**Re: Plan Review – Cloud Cap Inn Spring Reconstruction and Waterlines**  
**USFS Cloud Cap/Cooper Spur (PWS ID# [92634](#))**  
**Conditional Approval – PR #199-2021**

I received updated plans and specifications for the project referenced above on October 27, 2021, and emails regarding the plans on October 27, 2021 and November 29, 2021. The project involves reconstructing the existing spring and upgrading the existing distribution waterlines as shown in the figures below:

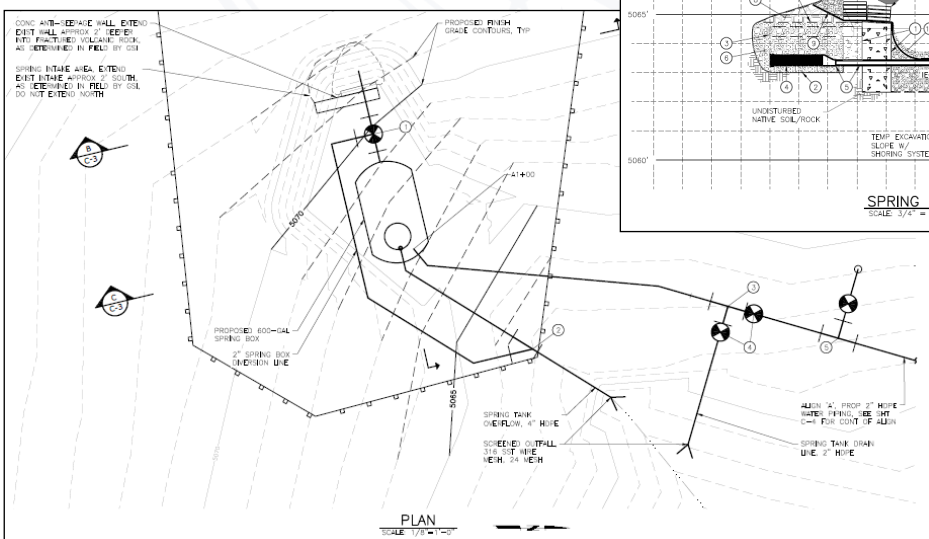
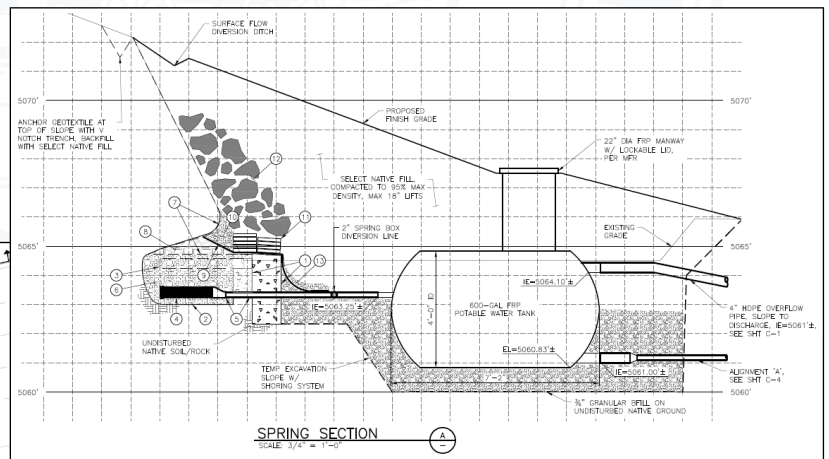
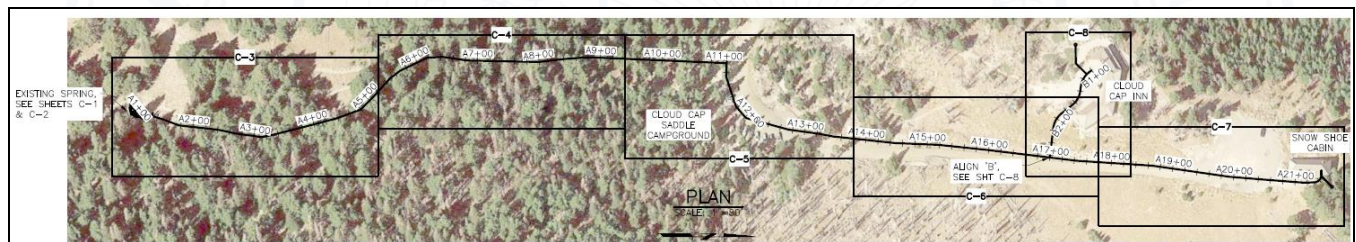
2. The Springbox will be provided with permanent security fencing as required under OAR 333-061-0050(2)(b)(A)(ii) – plans showed only construction fencing.

3. The interception ditch is placed to avoid surface water ponding above the springbox as well as above any other location (e.g., the perimeter of the impermeable membrane) that may allow for ponded water to infiltrate the spring in such a way as to contaminate the groundwater. Because an interception ditch was shown on the plans, I will defer to GSI on the most appropriate placement of the interception ditch to avoid such contamination so long as it meets the requirement under OAR 333-061-0050(2)(b)(A)(i).
